- **Agenda Item TE26.14 – “Designation of the King-Spadina Heritage Conservation District under Part V of the Ontario Heritage Act”**
- **Notice of Objection filed on behalf of Sun Life Assurance Company of Canada re: 100 Simcoe Street and 211 Adelaide Street West *et. al.***

Re: 100 Simcoe Street, Inclusion on the City of Toronto's Heritage Register - Item No. TE22.18

Re: 100 Simcoe Street, Inclusion on the City of Toronto's Heritage Register - Item No. PB20.2

South elevation detail showing fenestration pattern and rhythm compromised

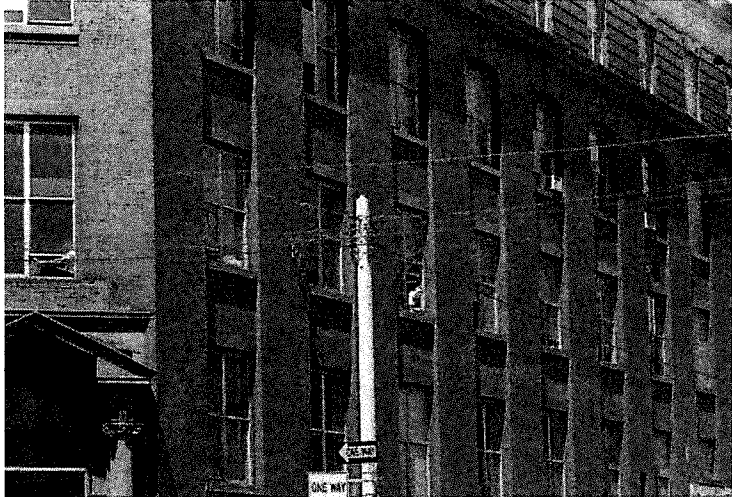
The fenestration on the south elevation has been substantially modified. The placement, size, and proportion of the first floor openings in the two easternmost bays are completely changed, compromising the rhythm of the original elevation. Moreover, the modern replacement windows have steel lintels and concrete sills.

fenestration altered
